Dam ID: HI00066  
LOWER ANAHOA

STATE OF HAWAII - DLNR  
DAM SAFETY INSPECTION SHEET

Inspection No: \_\_\_\_\_  
Date: 4/8/06

### 9. Outlet Works:

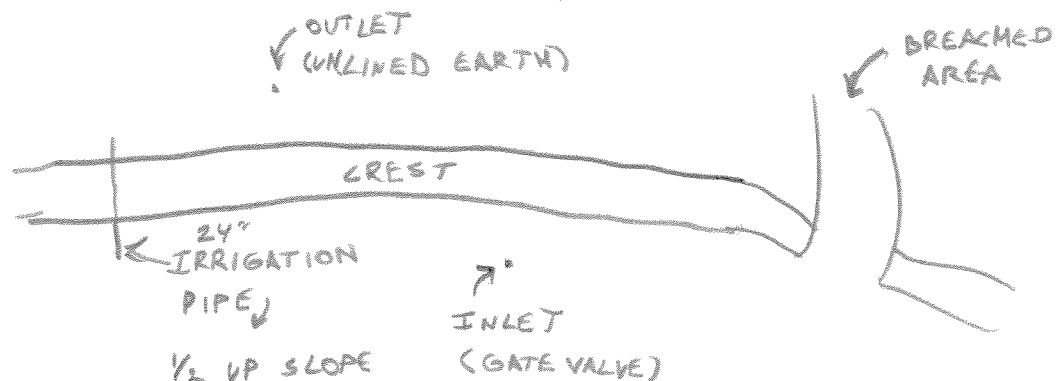
Type / Size: SEE SKETCH  
GATE VALVE ENTRANCE - UNSURE OF SIZE OF PIPE - EARTH LINED

- ☐ j. UNSURE OF HOW INLET (CULVERT) & OUTLET (UNLINED EARTH) ARE CONNECTED  
IRRIGATION DIVERSION PIPE APPEARS TO BE RARELY USED. TOO HIGH ON D  
NO ACCESS TO OUTLET WORKS GATE VALVE.
